ATTACHMENT 1

Letter from C.R. Steinhardt (WPSC)

April 15, 1998

Proposed Amendment 152

FIGURE TS 2.1-1

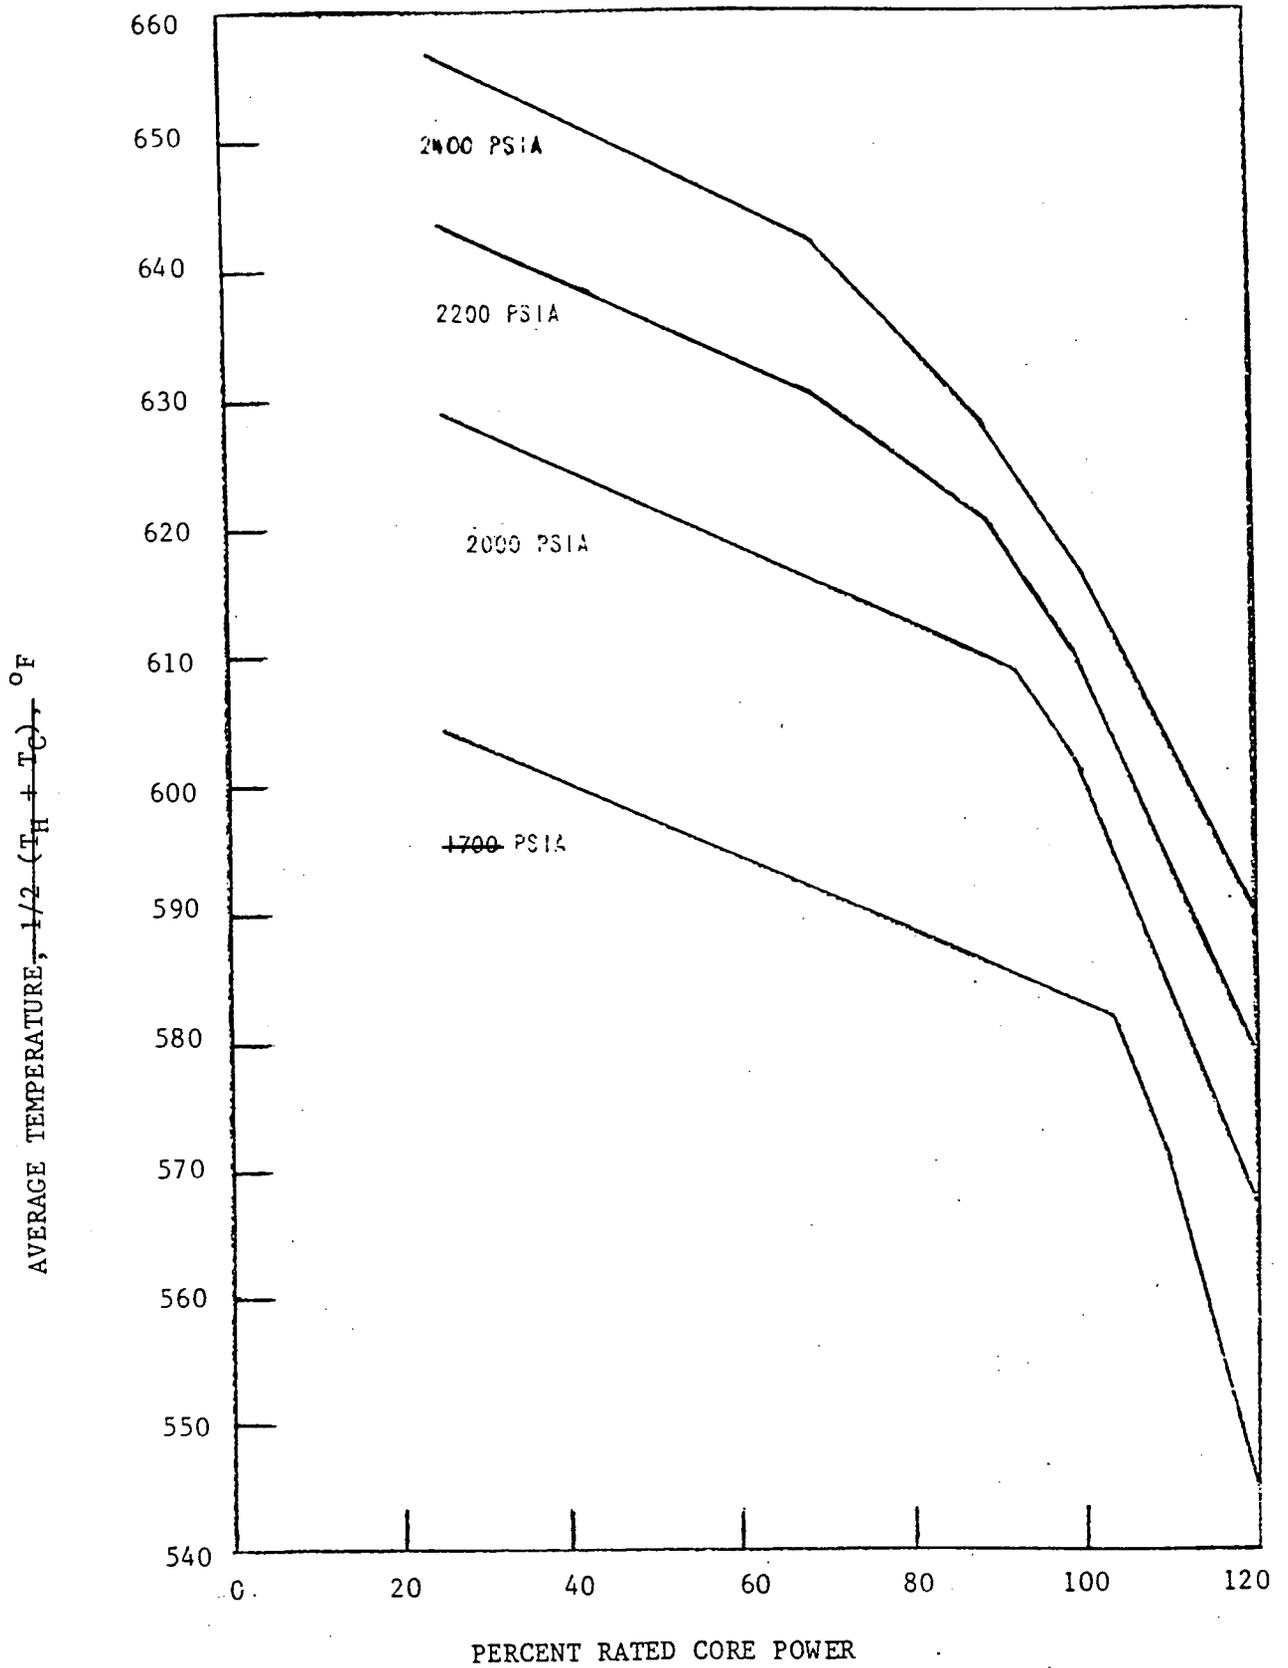
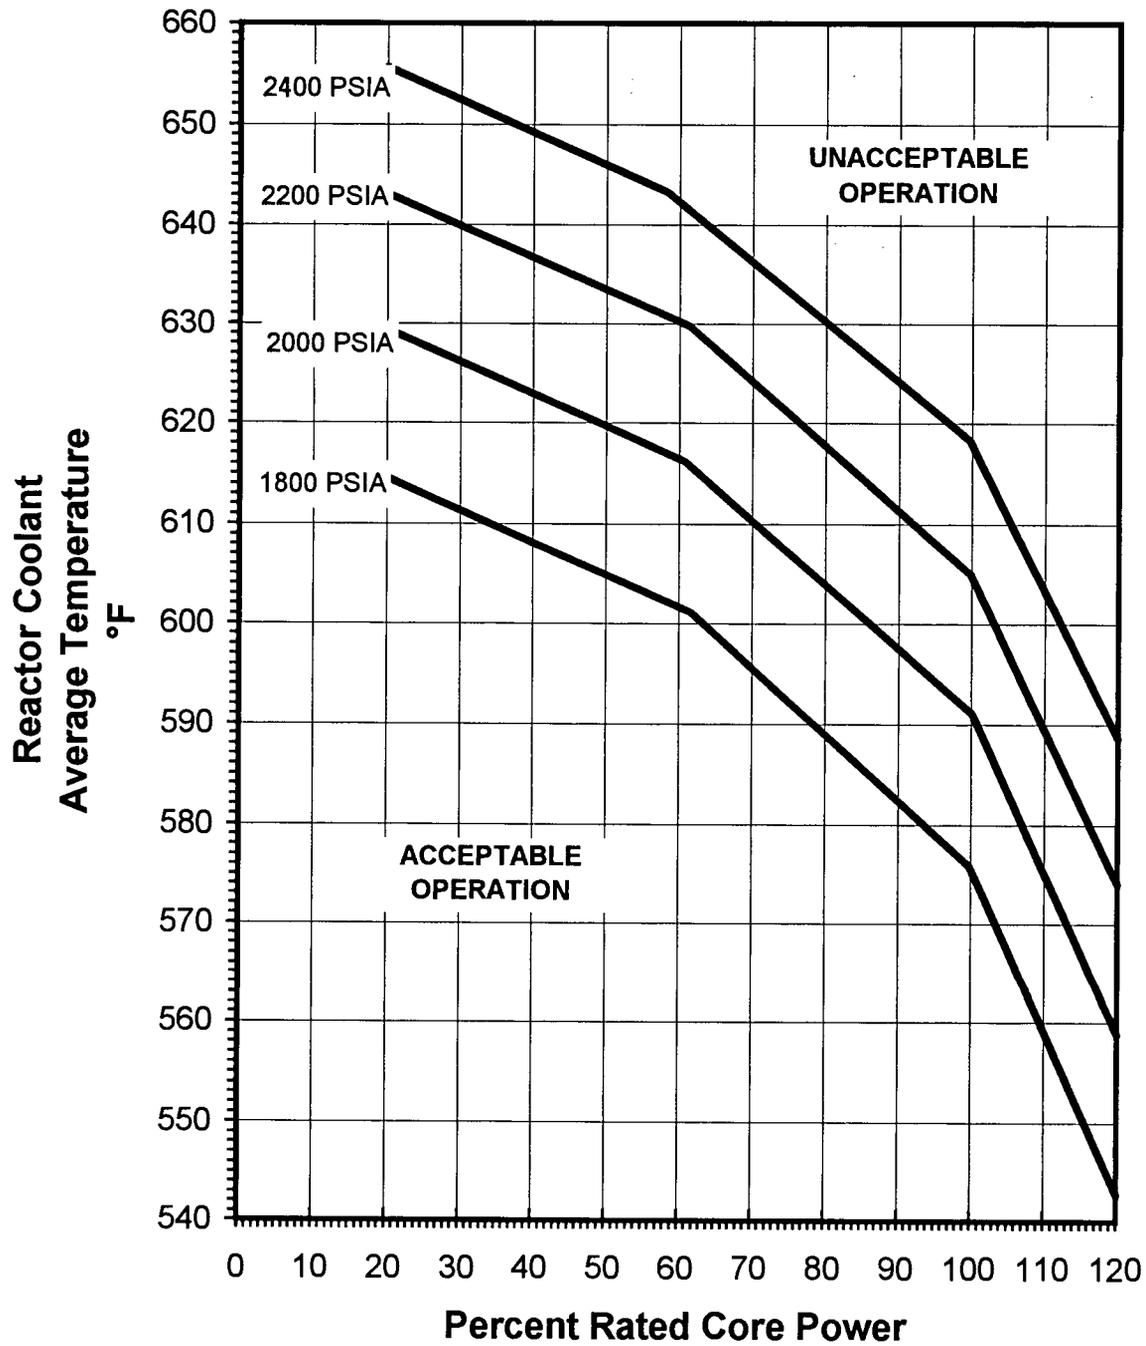
- 1) Figure 2.1-1 is revised to reflect the recently approved High Thermal Performance (HTP) Critical Heat Flux (CHF) correlation and corresponding Departure from Nucleate Boiling Ratio (DNBR) limit of 1.14. The figure also reflects changes in peak rod power and minimum reactor coolant flow.

The Departure from Nucleate Boiling (DNB) correlation and the associated Minimum DNBR limit were changed in this section. Additionally, the minimum reactor coolant flow and corresponding peaking factor limits were changed. The new safety limits curves are a result of changes to DNBR limit, Critical Heat Flux (CHF) correlation, Reactor Coolant System (RCS) flow, peaking factors and fuel design. The new curves will bound operation with Siemens Power Corporation standard or heavy fuel. A safety evaluation for the change to the CHF correlation was previously performed and approved (Reference 2).

The proposed changes to the safety limits curves do not alter the plant configuration, operating set points, or overall plant performance. The safety limits curves reflect the changes to the DNBR limit, CHF correlation, RCS flow peaking factors and fuel design. The significant hazards determinations for these parameters are evaluated later in this submittal. Therefore, the change will not increase the consequences of an accident previously evaluated.

The revised safety limit curves have been developed using operating parameters at their bounding values (e.g., rod powers at the peaking factor limits, reactor coolant flow at the minimum operating limit). The revised curves will bound plant operation with Siemens Power Corporation standard or heavy fuel. Therefore, this change will not involve a significant reduction in safety margin.

FIGURE TS 3.10-1

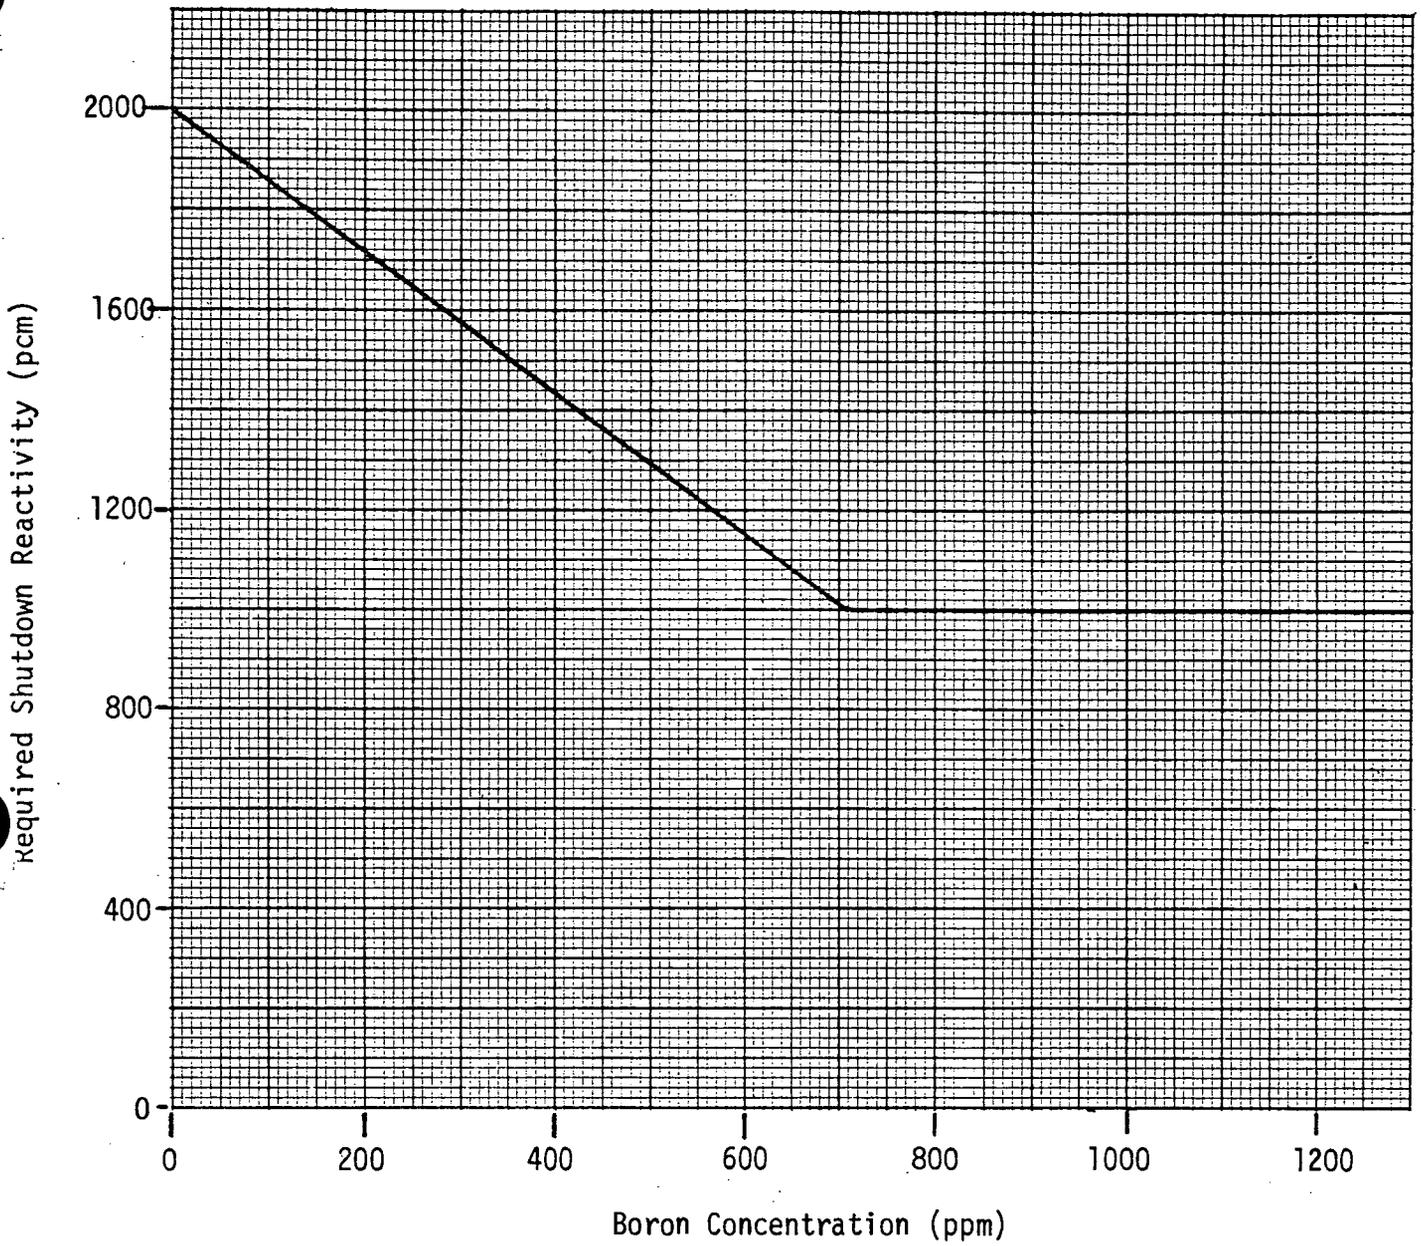
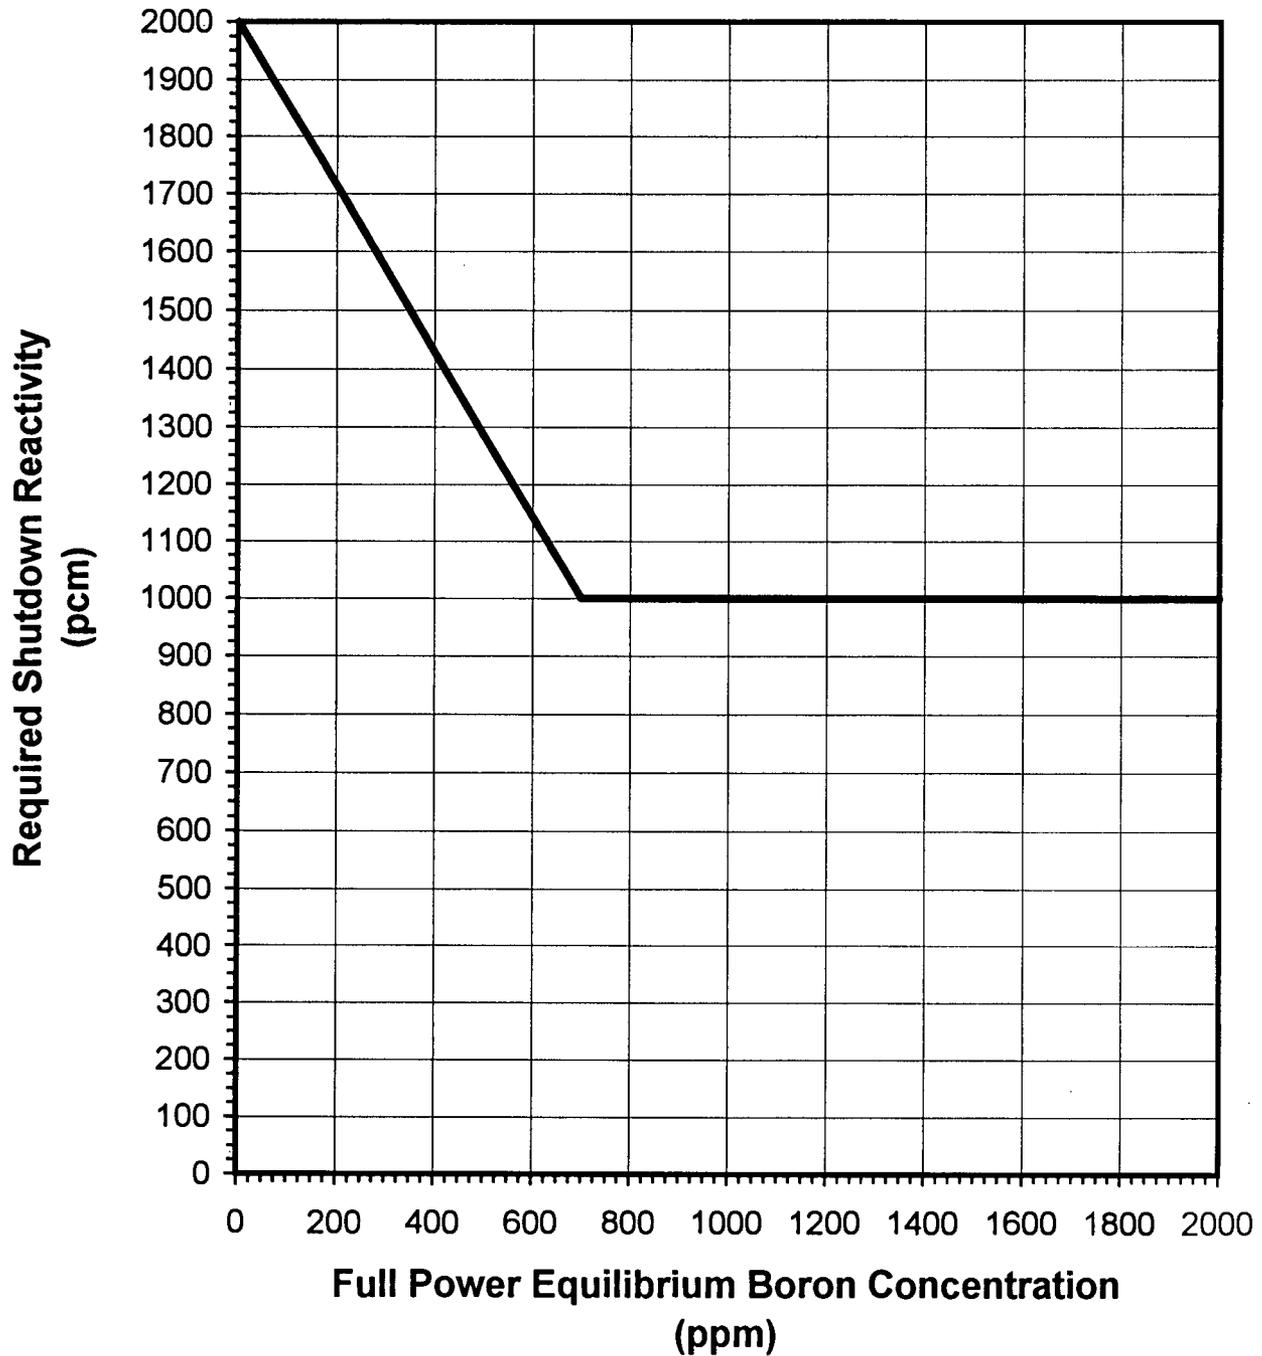
- 6) Paragraph TS 3.10.n - this specification was changed to reflect the approved Minimum DNBR limit.
- 7) Figure TS 3.10-1 - the Required Shutdown Reactivity vs. Boron Concentration was revised to reflect the change to an 18 month fuel cycle.
- 8) Figure TS 3.10-2, the Hot Channel Factor Normalized Operating Envelope was revised to reflect the values used in the safety analyses.
- 9) The Table of Contents and the Basis sections are being revised accordingly and are being submitted for information.

This figure of the Technical Specifications for Required Shutdown Reactivity vs. Boron Concentration was revised to reflect the values used in the safety analyses. The limits for the shutdown margin were not changed. The boron concentration values were extended to account for the longer fuel cycles.

This change is administrative. The required shutdown reactivity line was extended from 1300 ppm to 2000 ppm. The existing values on the figure are not changed in the analysis or in the Technical Specifications. Therefore, the change will not affect the health and safety of the public.

Required Shutdown Reactivity vs. Boron Concentration was revised to reflect the longer cycle length and the resulting increase in boron concentration.

FIGURE TS 3.10-2

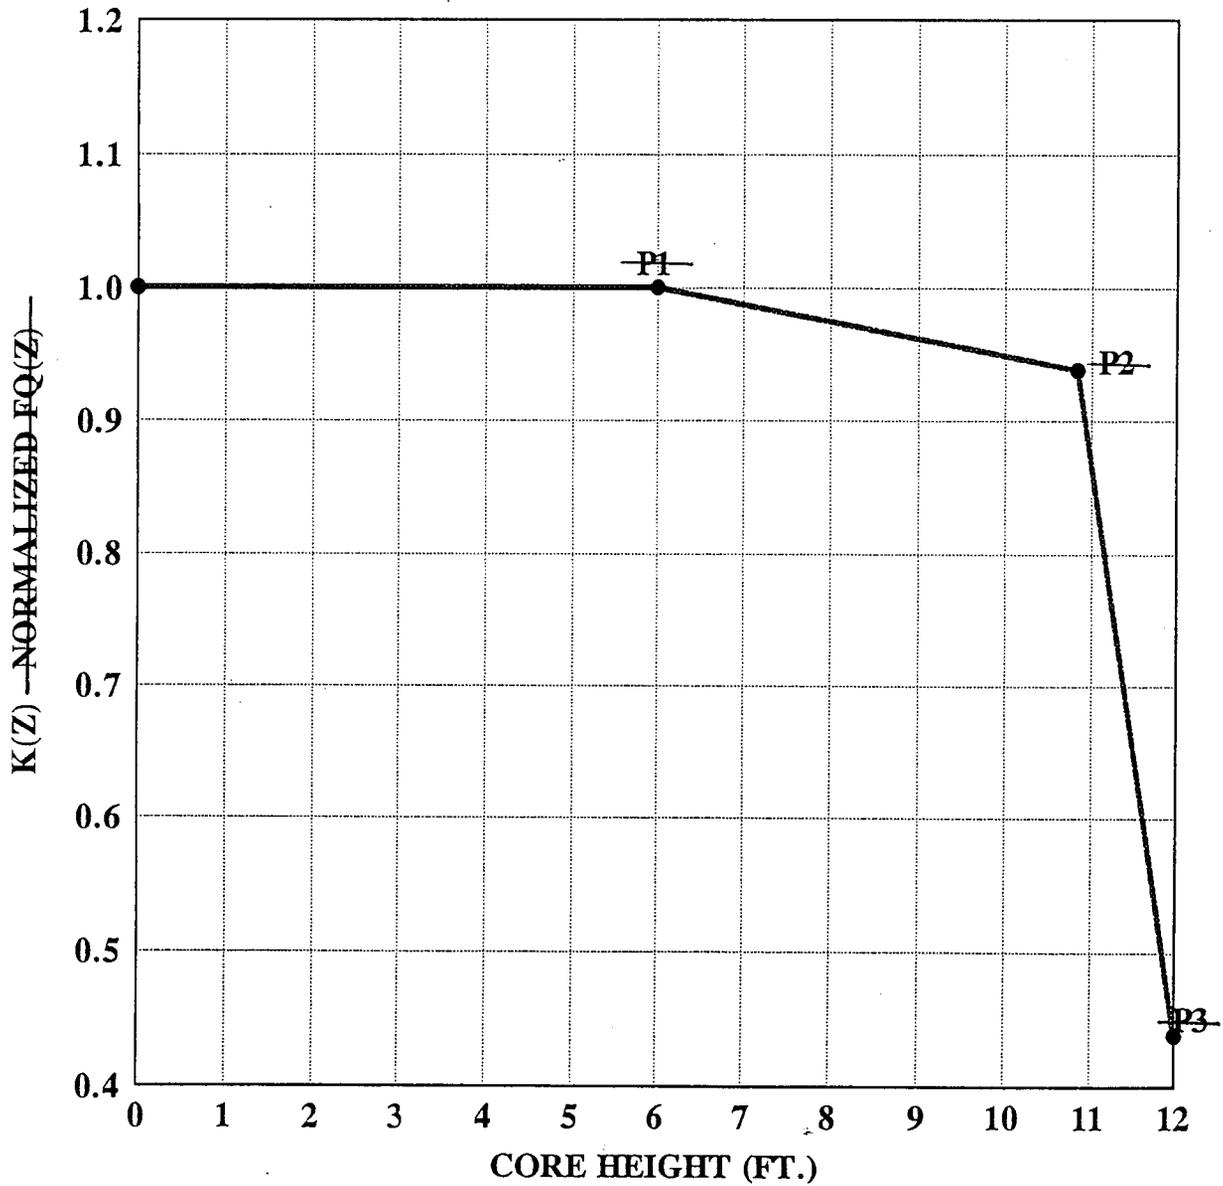
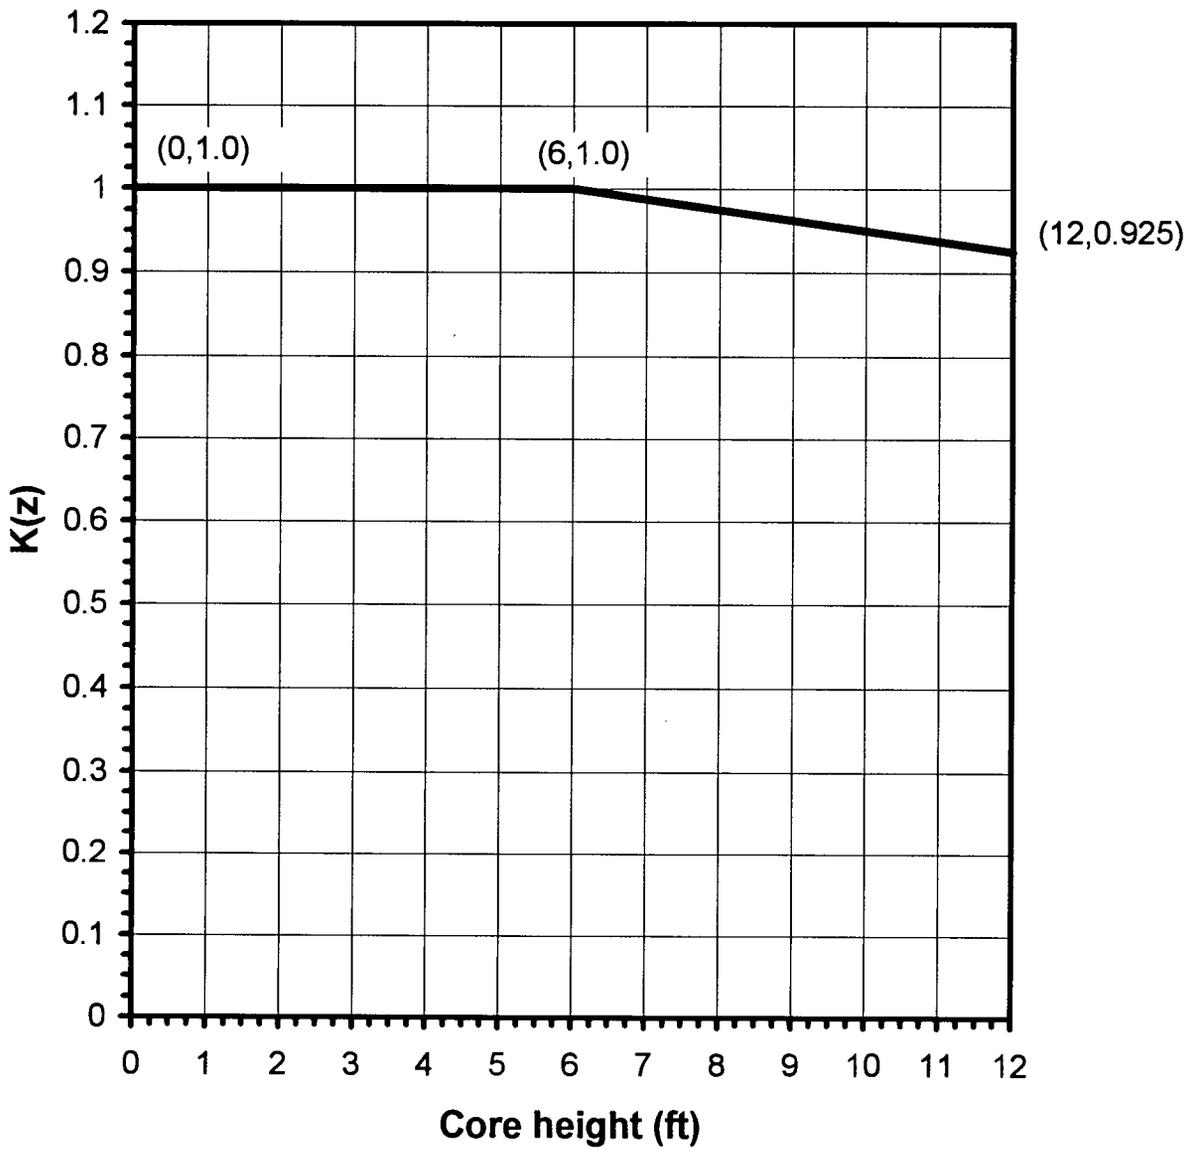
This technical specification figure for Hot Channel Factor Normalized Operating Envelope was revised to reflect the values used in the safety analyses.

The Hot Channel Factor Normalized Operating Envelope figure was revised to reflect the values used in the safety analyses.
